ADDENDUM NO. 1

UOSA Laboratory Renovations Project

(UOSA Contract LB)

UOSA Contract LB

PROJECT NO: 20885-281909
 FILE NAME: HPV2001LB.rvt
 SHEET NO:
P-32

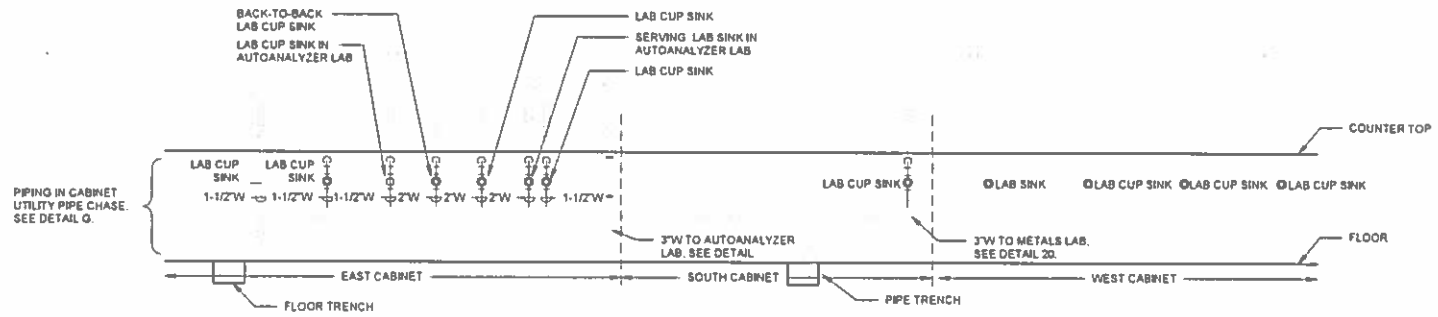
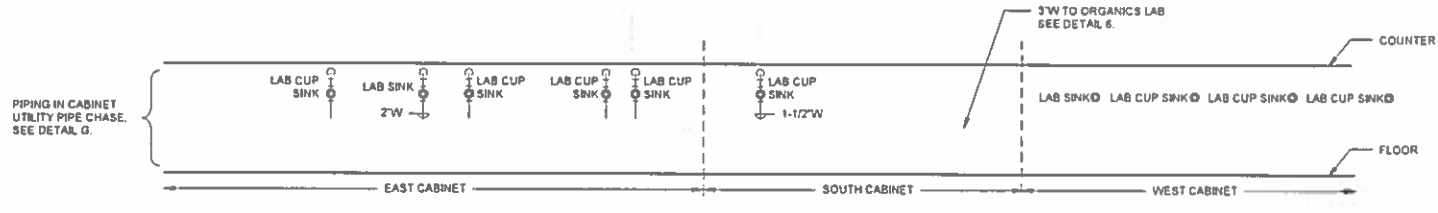
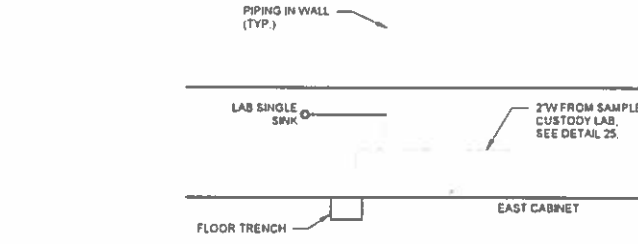
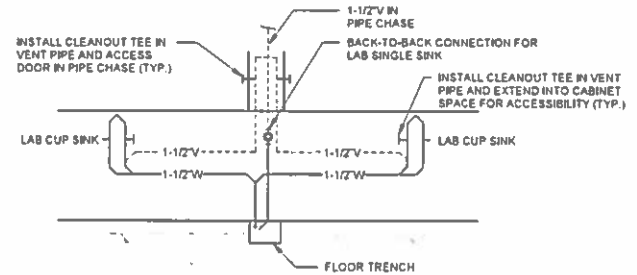
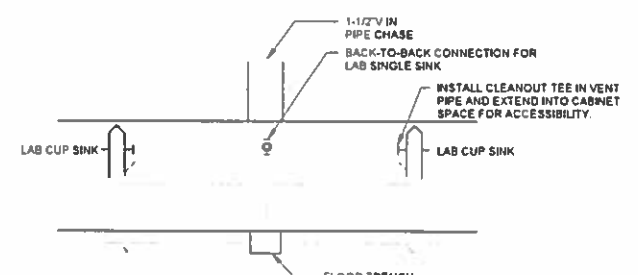
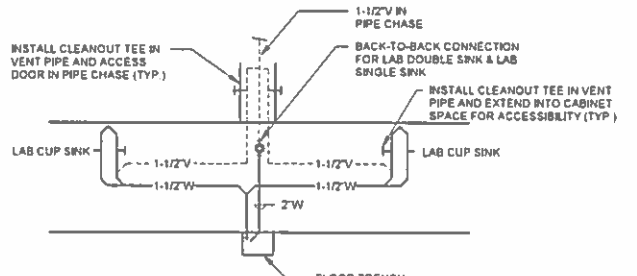
REPLACE: Sheet # P-32 with the attached Sheet # P-32.
